Department of Planning and Zoning

MEMORANDUM

To: Development Review Board
From: Mary O'Neil, AICP, Senior Planner *moniel*
Date: January 6, 2014
RE: ZP15-0468CA; 166 East Avenue

Request: Addition to existing duplex.

SITE PLAN

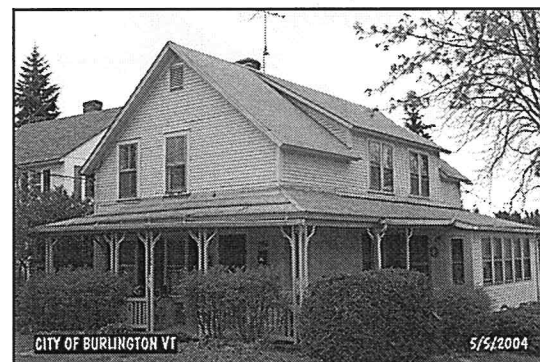
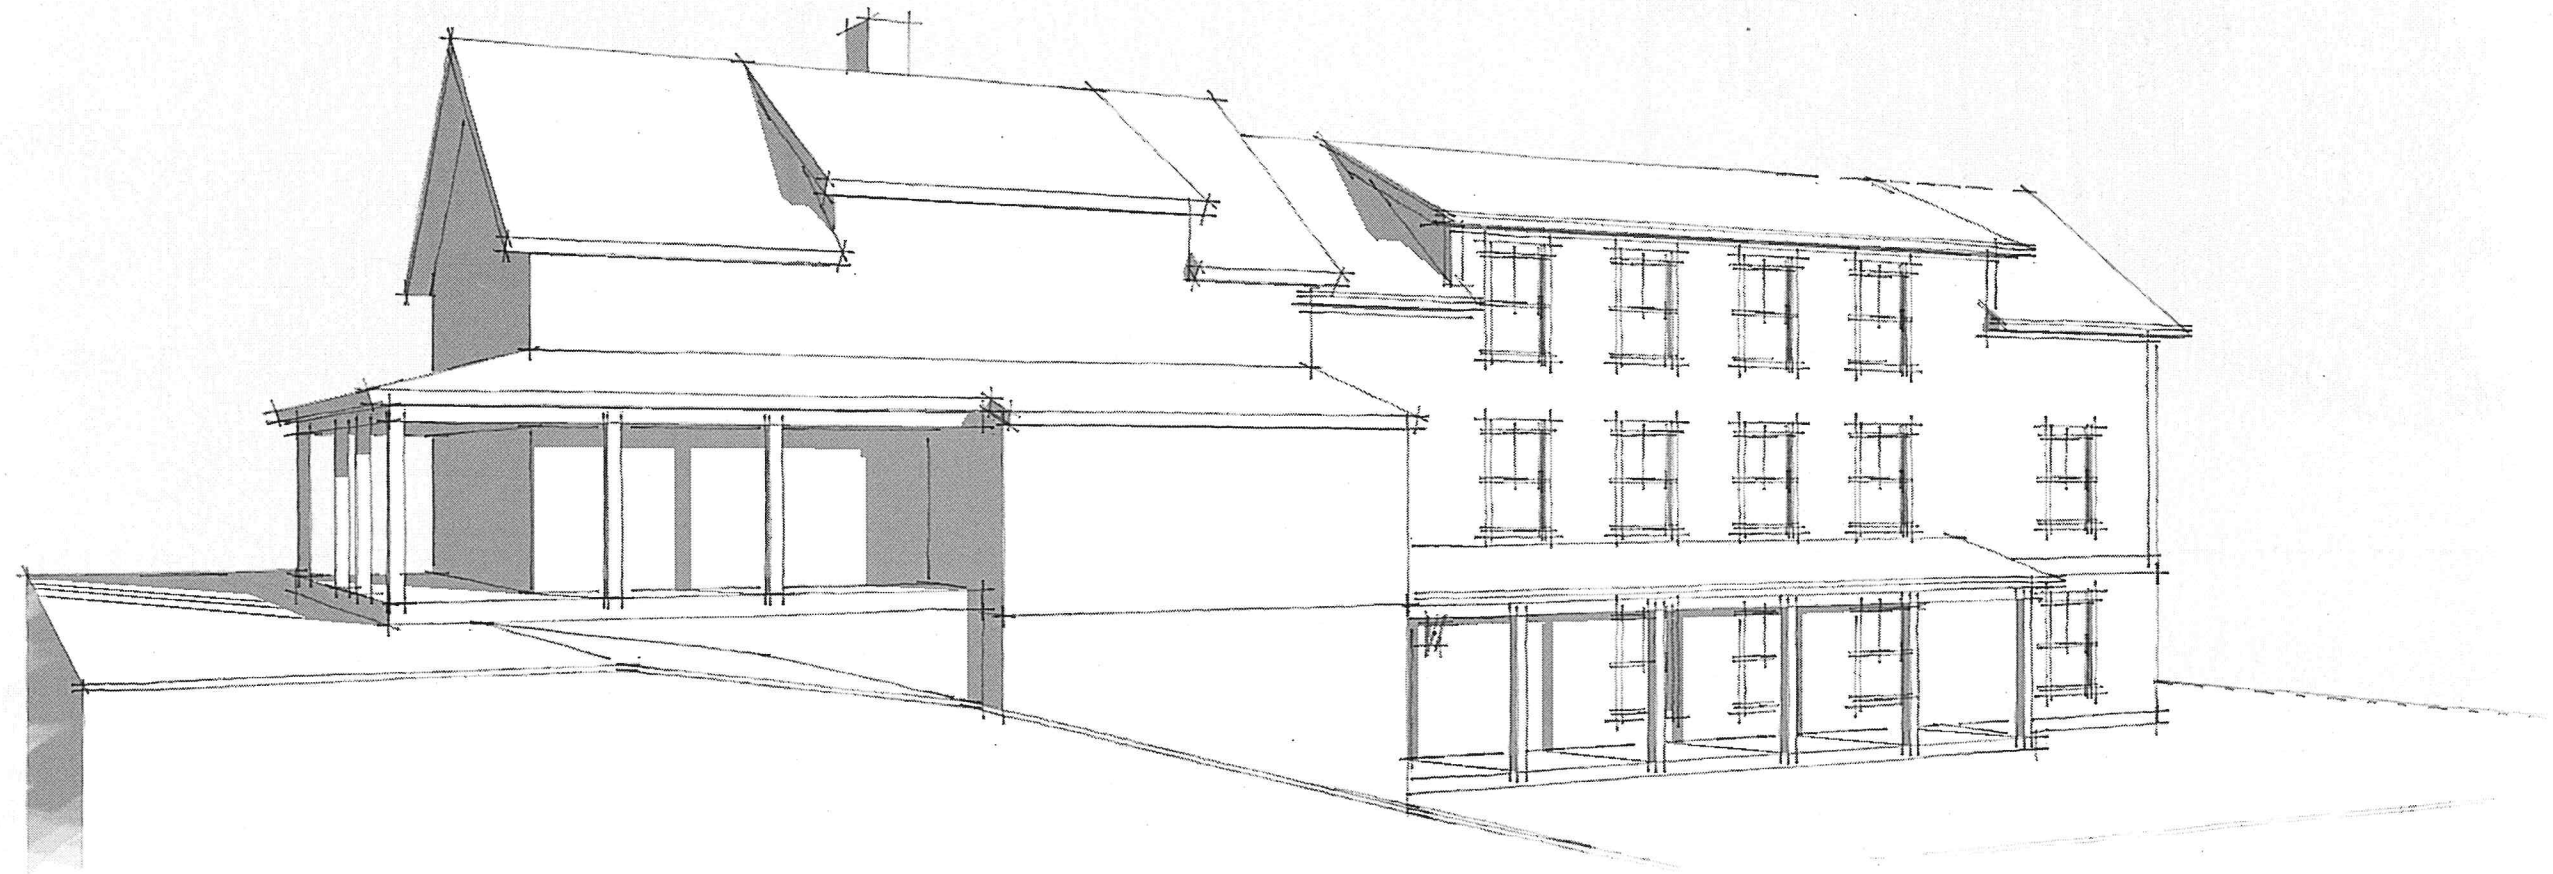
The proposed driveway/parking area is illustrated 3' from the side (south) property line, and therefore not conforming to this standard. See Table 4.4.5-3 for required setback standards. **Adverse finding.**

The submitted site plan for existing conditions does not match aerial and historic ortho views of the parking pattern on the property. Since 1978, it is clear that the parking has moved away from a circulation pattern to the rear garage, toward a curved pattern that appears to cross property lines to the south.

A revised site plan submitted 12/14/2014 shows parking for four vehicles; however it encroaches into a required side yard setback. A minimum 5' setback is required for parking areas.

Additionally, some barrier will be required to specifically define the parking area and to prevent parking lot creep, as is evident in ortho photos from 1978. Revised plans include paving of the new driveway. Some method to contain the parking must be provided.

Table 8.1.8-1 requires 2 parking spaces for each residential unit within the Neighborhood Parking District. Although the revised site plan illustrates 4 spaces (for 2 units), meeting the requirement for the parking district, the parking area encroaches into a required side yard setback. See Table 4.4.5-3, above. **Adverse finding** for parking area encroachment into setback.

5. **Parking barriers** shall be identified and installed to specifically define the parking area and to prevent parking lot creep.
6. A **lighting plan**, including fixture spec sheets and lumens measurement is required **prior to release of the zoning permit**.

REAR VIEW - SOUTH

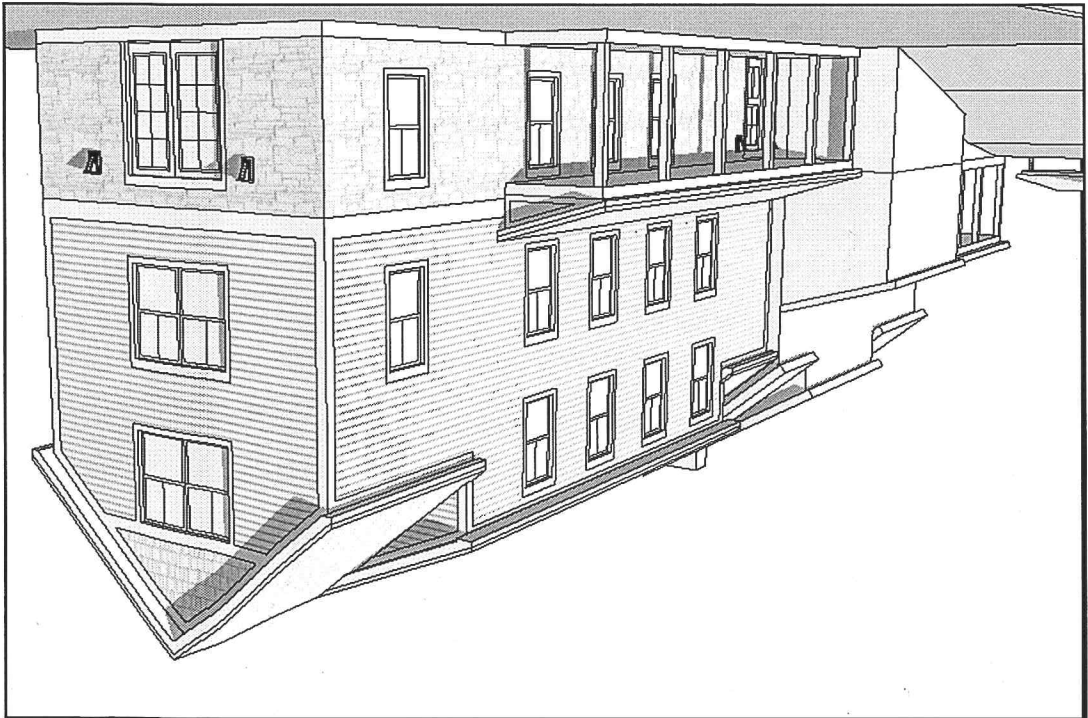
Window pattern on the southern elevation are rhythmic in their placement, and centered under the full dormer. Paired double hung sash are illustrated in the east elevation; the north elevation has only a handful of windows on the first and 2nd floor; none on the third. Presumably this is to provide privacy from the immediate neighbors. **Affirmative finding.**

8. The East elevation is mis-identified as the south elevation on plans. This needs to be corrected.
9. All development is required to meet energy efficiency standards as defined by Burlington Electric, and appropriate state energy efficiency codes now in effect.
